2.206 - FirstEnergy - Davis-Besse
(EDATS: OEDO-2010-0305)

This is a 2.206 letter.

Public Meeting Between NRC and NEI and PWR Licensees to Discuss Bulletin 2002-02

Schematic View of B&W Design CRDM Nozzle Area

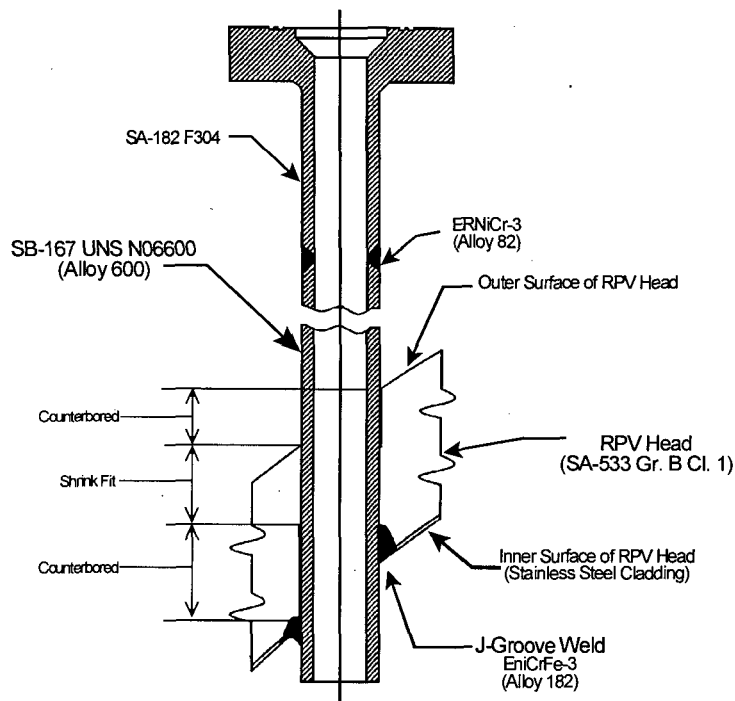
The counterbore shown in slide 10 of 36 tells me that the J-groove weld is made with a gap or space between the reactor head and the CRDM nozzle. I request that you order the FirstEnergy/Davis-Besse plant to remain shut down until you are sure that the weld qualification for this weld was made with a similar gap, and passed the test.
